**SUBJECT: VIRGIL C. SUMMER NUCLEAR STATION, UNIT NO. 1 – ISSUANCE OF
AMENDMENT TO REVISE TECHNICAL SPECIFICATION 3.5.4 LIMITING
CONDITION FOR OPERATION REFUELING WATER STORAGE TANK
(CAC NO. MF8310)**

Amendment No. 207
Renewed License No. NPF-12

SAFETY EVALUATION BY THE OFFICE OF NUCLEAR REACTOR REGULATION

Spent Fuel Pit Cooling Purification Loop RWST Riser Loop Seal

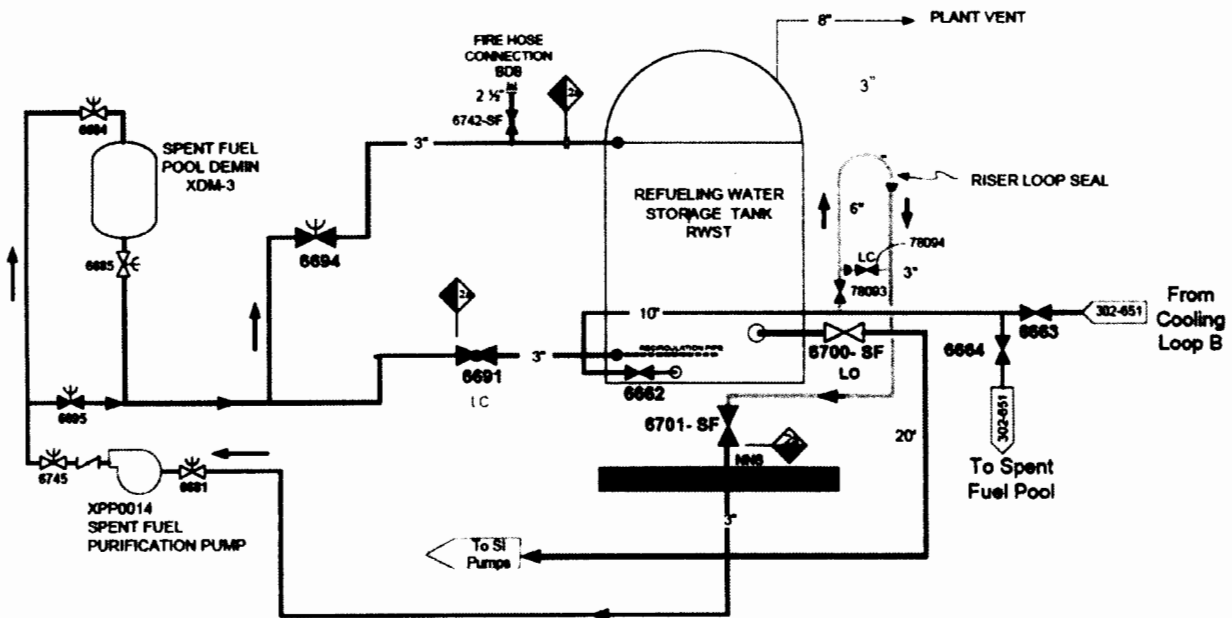
Since the issuance of Amendment 192, SCE&G has implemented a modification to prevent a loss of RWST inventory below the required level for operability in the event of failure of non-safety related piping while using the spent fuel purification system to recirculate or filter the RWST water. The modification included installation of a seismically qualified, safety-related raised loop seal in the suction line from the RWST to the spent fuel purification system. The top of the raised loop seal is connected by piping to the main RWST vent. The modification is shown in the below diagram of the RWST and connected piping, which was provided as Attachment 5 to the LAR.

The modification and administrative controls on certain valve positions in operating modes 1 through 4 protect the required TS RWST coolant inventory from loss in the event of a failure of non-safety spent fuel purification system piping. In the unlikely event of a failure of the non-safety related purification system piping, the elevation of the upper return line RWST tank penetration and the siphon break provided by the vent in the raised loop seal would prevent loss of inventory through these lines below the TS required level. The licensee verified the siphon break would function to prevent inventory loss without operator action during post-modification testing. Administrative controls that require maintaining safety-related valves in the lower purification system return line and the loop seal bypass lines in the locked closed position when TS LCO 3.5.4 is applicable (operational modes 1, 2, 3, and 4) provide assurance that only the upper purification return line and the raised loop seal would connect the RWST with the non-safety related portions of the purification system.

During Refueling Outage 22 (fall 2015), SCE&G implemented a permanent plant modification under 10 CFR 50.59 that replaces the requirement for the Note. SCE&G installed a seismically qualified, safety-related riser loop seal from the RWST and added administrative controls that

lock closed the purification system safety-related lower return line isolation valve and raised the loop seal bypass valve, eliminating the potential for loss of RWST inventory below the minimum required by TS LCO 3.5.4.

The proposed changes to TS LCO 3.5.4 eliminate restrictions on RWST connection to the purification system in operating modes 1, 2, 3, and 4 have become unnecessary following implementation of the plant modification installing a raised loop seal on the purification system suction line from the RWST. The staff found this change acceptable because the modification allows the system to be configured such that the requirements of GDC 2 are maintained with respect to maintaining RWST inventory during recirculation or filtering of the RWST. This plant-specific change to the design has eliminated the basis for the TS LCO 3.5.4 note, and, therefore, the note may be deleted consistent with the requirements of 10 CFR 50.36 and the guidance of Standard Review Plan Section 16.0. The safety analysis provided in the proposed bases to TS 3.5.4 present the design basis information supporting operation of the purification system for RWST recirculation and filtering in operating modes 1, 2, 3, and 4, consistent with the requirements of 10 CFR 50.34.
